October 29, 2018

NOTICE OF ADDENDUM  
 ADDENDUM NO. 2  
 CONTRACT NO. 8104  
 SHEPARD TERRACE, CHAMBERLAIN AVENUE,  
 VAN HISE AND MASON STREET ASSESSMENT DISTRICT – 2018

REVISED 10/29/18 EEA

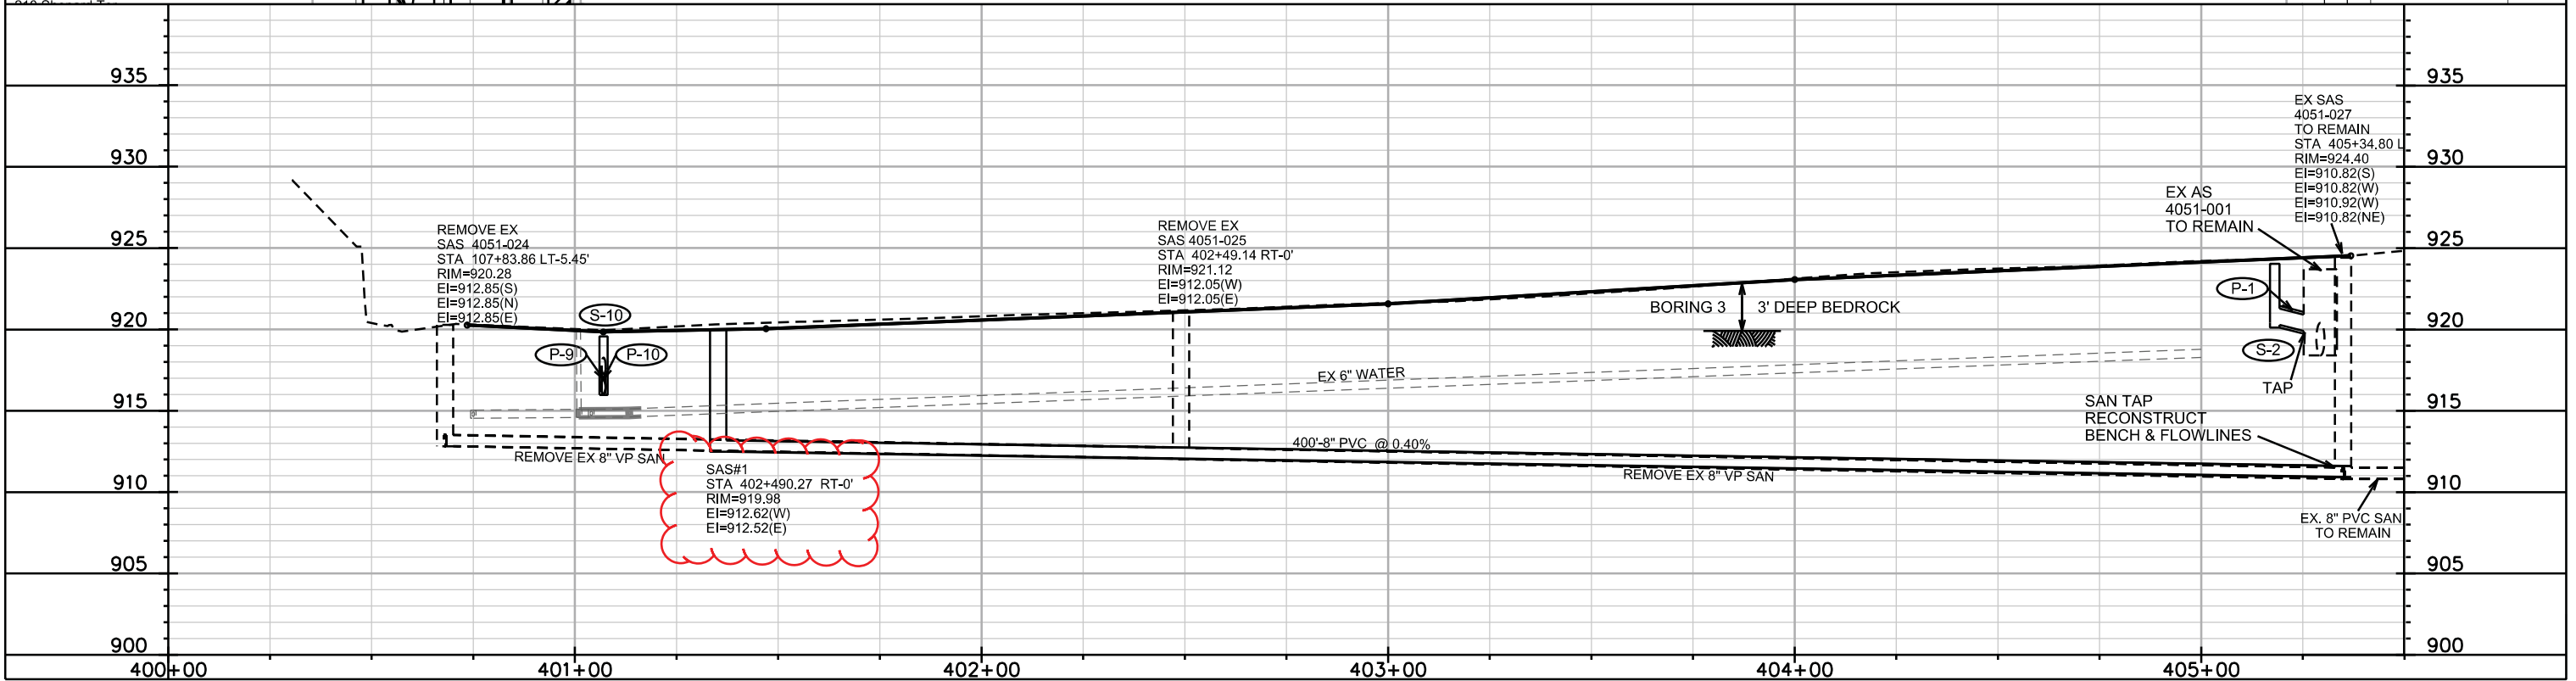
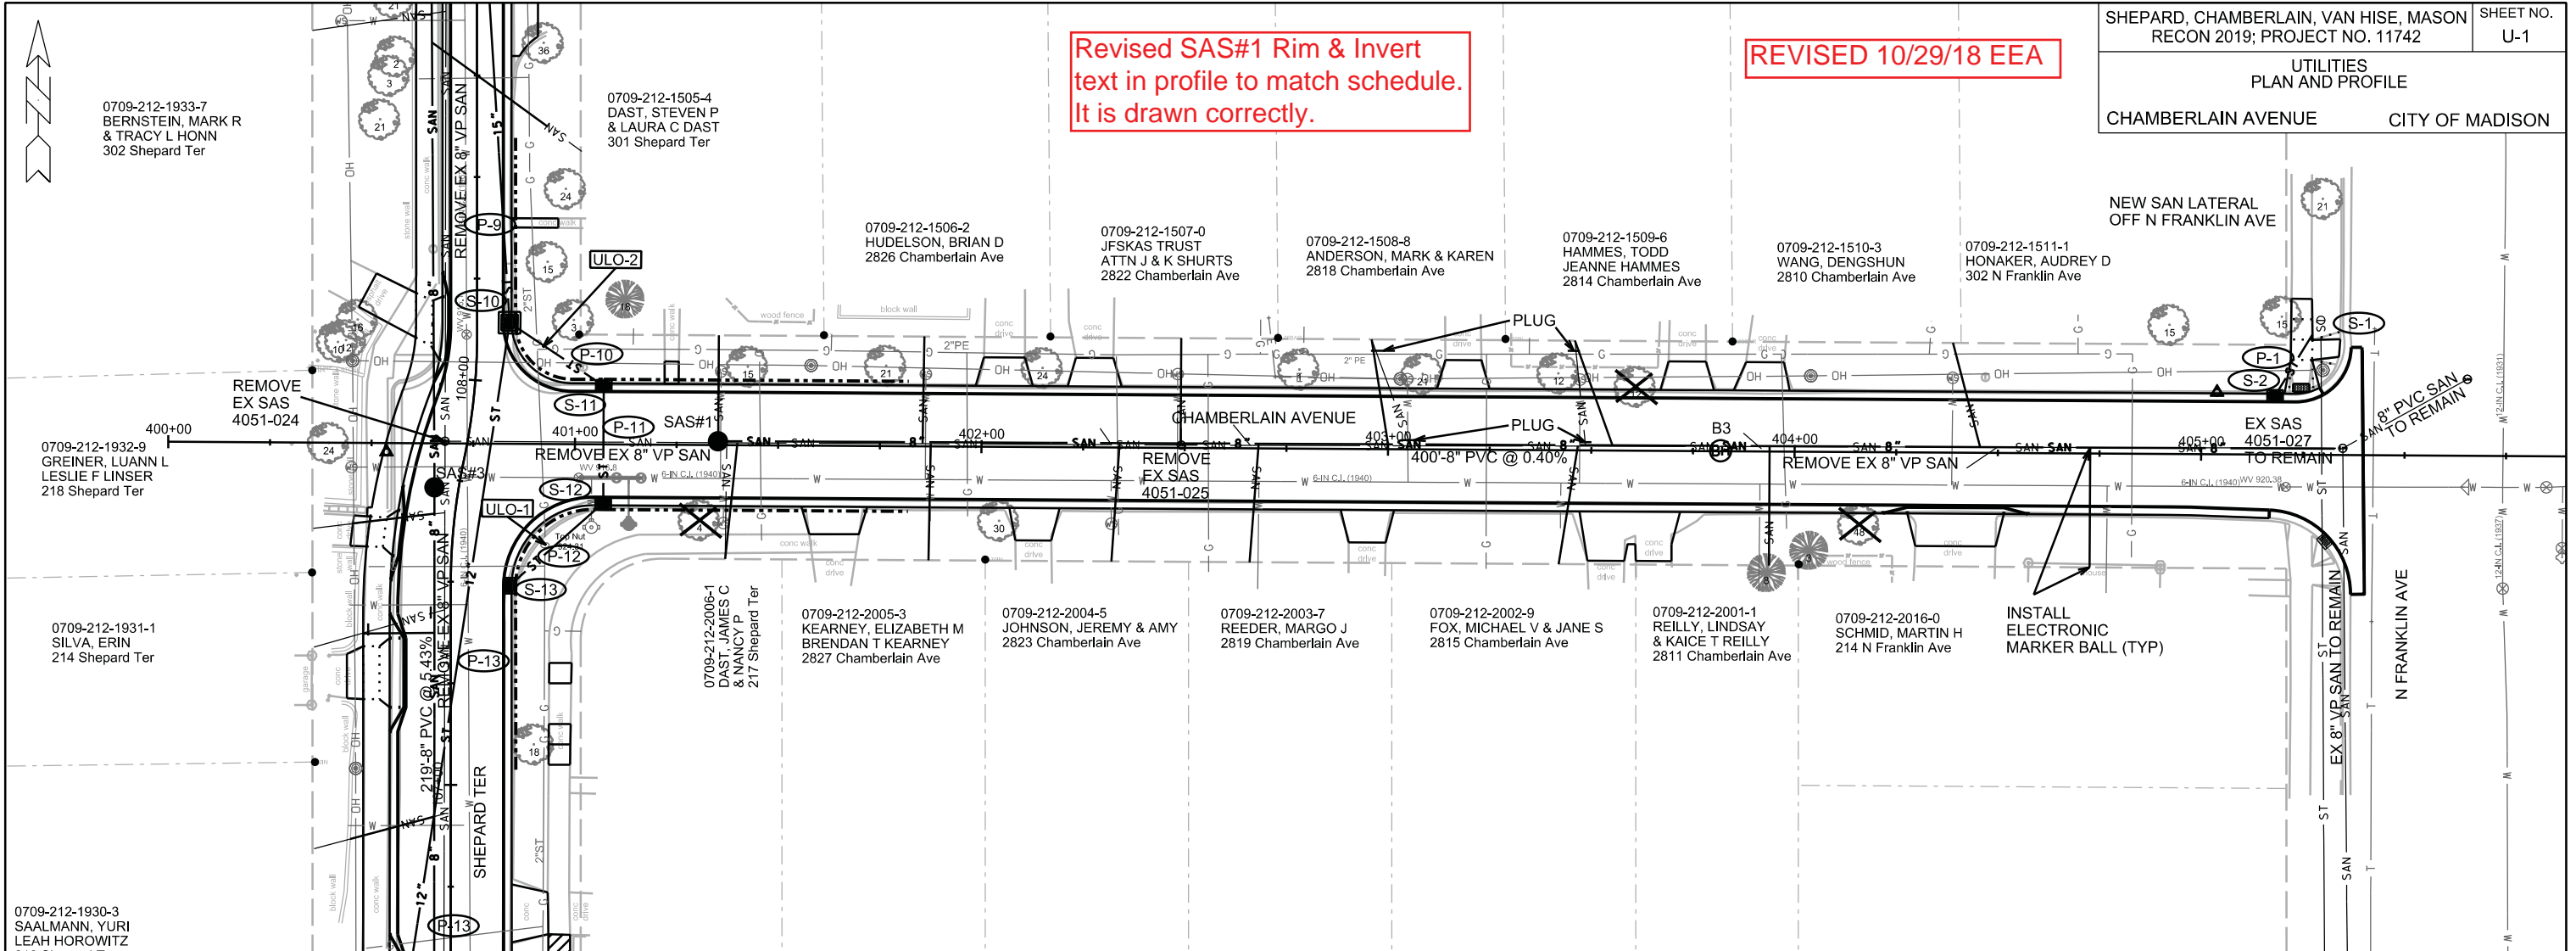
- U-1: Revised SAS#1 Rim and EI text only to match sanitary sewer schedule. It is drawn correctly.
- U-5: Revised storm sewer to move pipe further away from stone wall. Specifically, added field bend S-14A and moved S-14 further north on curb. Revised pipes P-13 & P-14 and added pipe P-14A.
- U-7: Revised storm sewer schedule to reflect storm sewer design change. Deleted all Type II pipe, all pipe shall be Type I.

Revised SAS#1 Rim & Invert  
 text in profile to match schedule.  
 It is drawn correctly.

REVISED 10/29/18 EEA

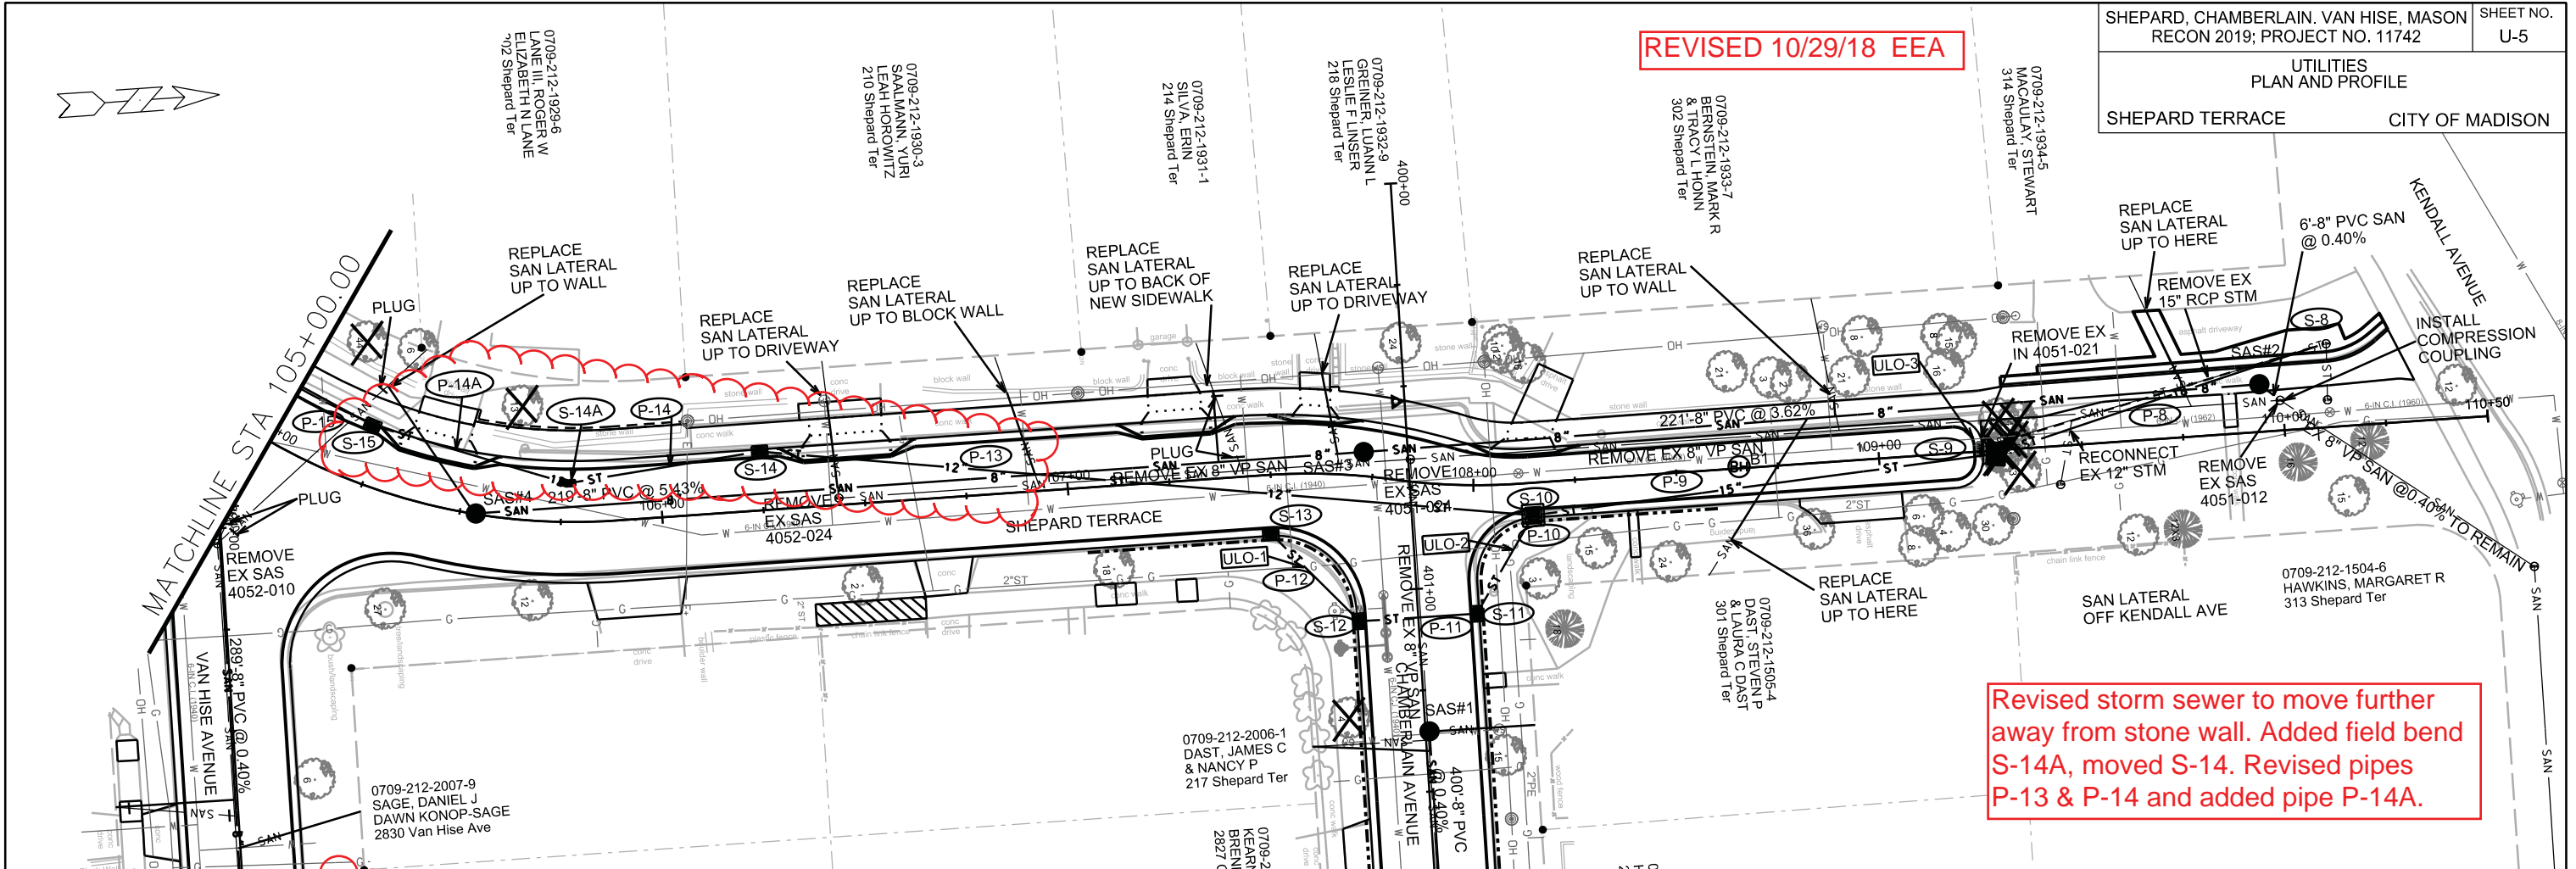
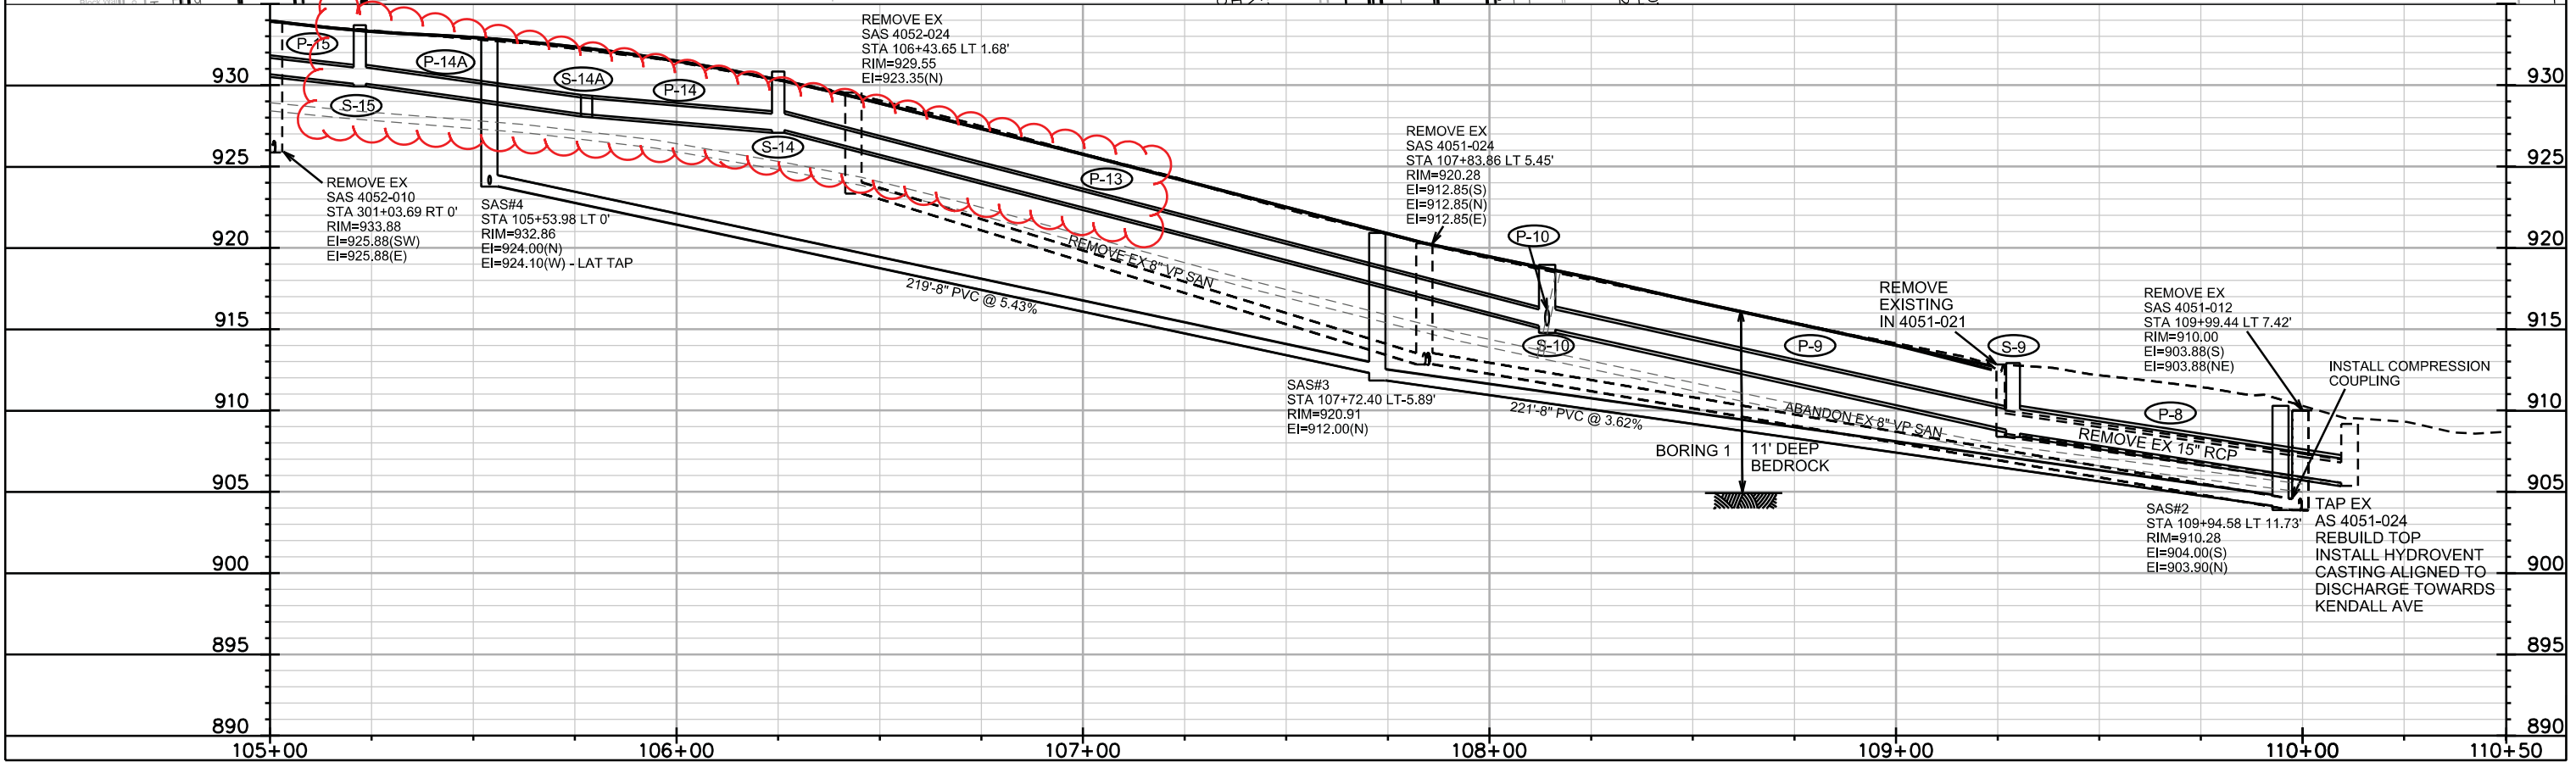
Revised storm sewer to move further away from stone wall. Added field bend S-14A, moved S-14. Revised pipes P-13 & P-14 and added pipe P-14A.
